# Red Hill Bulk Fuel Storage Facility, Oahu, Hawaii

September 7, 2022 Defueling Plan Supplement 1.A

E. Defueling Plan Timeline Updates .....	11
F. DoD’s Upcoming Supplement .....	12
<b>II. RESPONSES TO DOH COMMENTS</b> .....	13
<b>GENERAL COMMENTS</b> .....	13

Figure 1- Red Hill JP-5 Pipeline

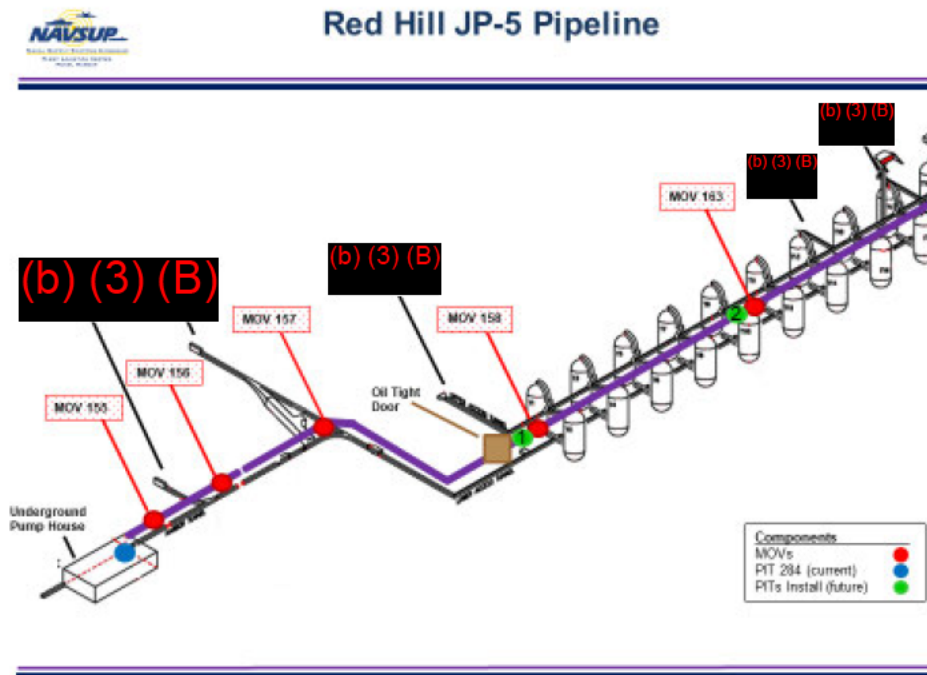
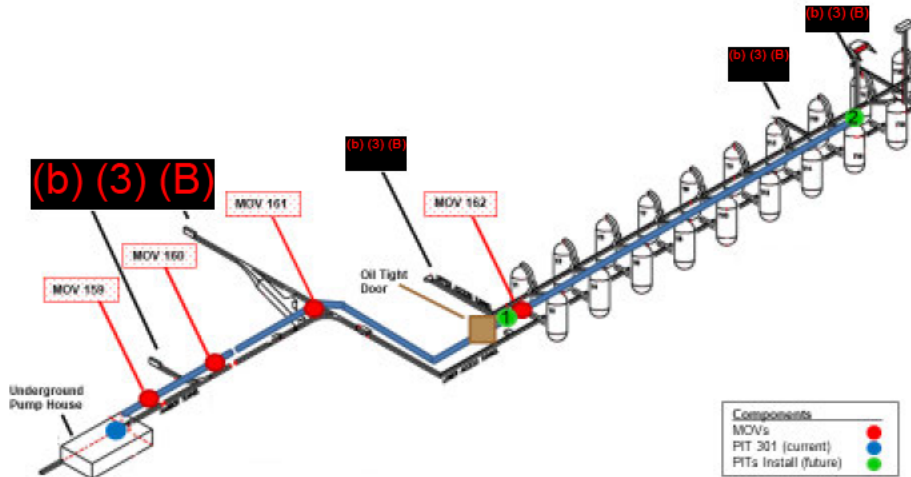
- a. Page 2 states, "All three product pipeline systems contain some fuel, and some of the infrastructure repairs (e.g., JP5 [sic] pipeline repairs, installation of Pressure Indicator Transmitters (PITs), etc.) cannot commence until those lines are unpacked." However, Page 15 states, "To enhance safety of the unpacking process, DLA is contracting for 14 additional Pressure Indicating Transmitter sensors. These sensors go into all three fuel lines to provide continuous reading of the pressure in the pipe and would allow the operators to detect in real time and address any pressure anomalies during operations." Will the unpacking*

occur to allow for the pressure indicating transmitter sensors to be installed, or can they be installed safely with fuel in the system for the purpose of unpacking for other repairs? Provide information on the planned location of these 14 PIT sensors. Confirm that the Pressure Indicator Transmitters are the same as the Pressure Indicating Transmitter sensors.

**Response:** The Pressure Indicator Transmitters mentioned are synonymous with Pressure Indicating Transmitters (PITs). DoD must remove fuel from the pipelines prior to installation of the PITs.

DoD plans to install two additional PITs on the F-24 pipeline in the tank gallery and three additional PITs on the JP-5 pipeline in the tank gallery. DoD plans to forego using the F-76 pipeline and will instead use the JP-5 pipeline to transfer fuel out of the tanks containing F-76. DoD will inspect the pipelines out of the two F-76 tanks to confirm that they are still in good condition before defueling them using the JP-5 pipeline.<sup>7</sup> New PITs on the F-24 line will be located on the main pipeline downstream of the sectional valves near Tanks 1/2, and at the end of the line near Tanks 15/16. PITs on the JP-5 pipeline will be located on the main pipeline downstream of the sectional valves near Tanks 1/2, below the isolation valve near Tanks 10/11, and at the end of the line near Tanks 19/20. See the below schematics in figures 1 and 2.

The CPM schedule shows installation of all PITs by January 2023. DoD has amended its initial plan to install 14 PITs, reducing the number of PITs to five. It has done so for two reasons:

- 1) DoD has elected to forego repairs on the F-76 pipeline and instead use the JP-5 pipeline to transfer fuel out of the two F-76 tanks at RHBFSF. Doing so eliminates the need to make repairs on the large 32-inch diameter pipeline and eliminates the need to install PITs on that pipeline.
- 2) DoD has elected not to install PITs near the UGPH. Installing these PITs would not provide significant additional information about vacuum conditions and thus would not provide a safety benefit.
